FERMILAB PPD/ETT/ES CDMS (E-891)
ZIP MODULE
QET FRONT END

SIZE	FSCM NO.	DWG. NO.	REV
C			2
SCALE		SHEET 5-2

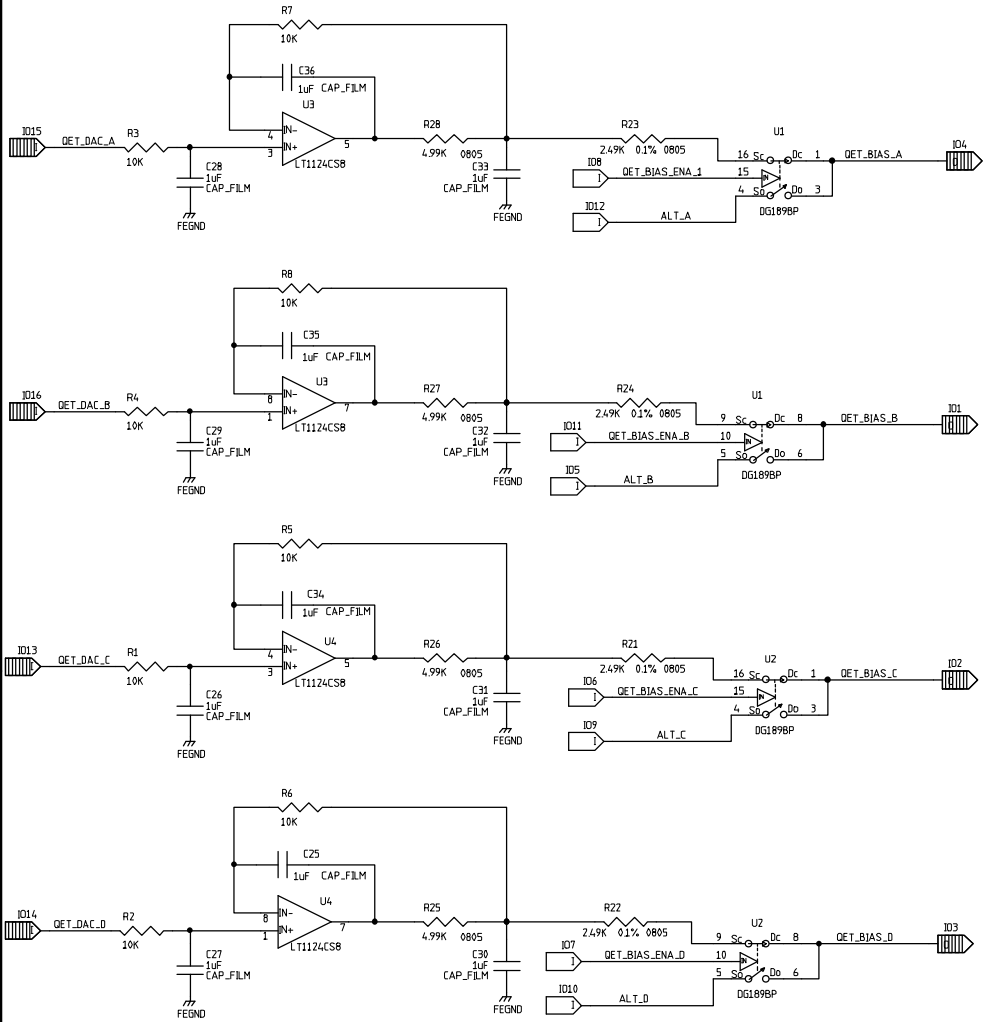
REVISIONS			
REV	DESCRIPTION	DATE	APPROVED
1	REPLACED 1uF CAPS WITH BACK TO BACK 4.7uF TANT. CAPS	2 29 00	BDM
2	REPLACED RESISTORS R21-R24 WITH 2.49K	3/28/01	BDM
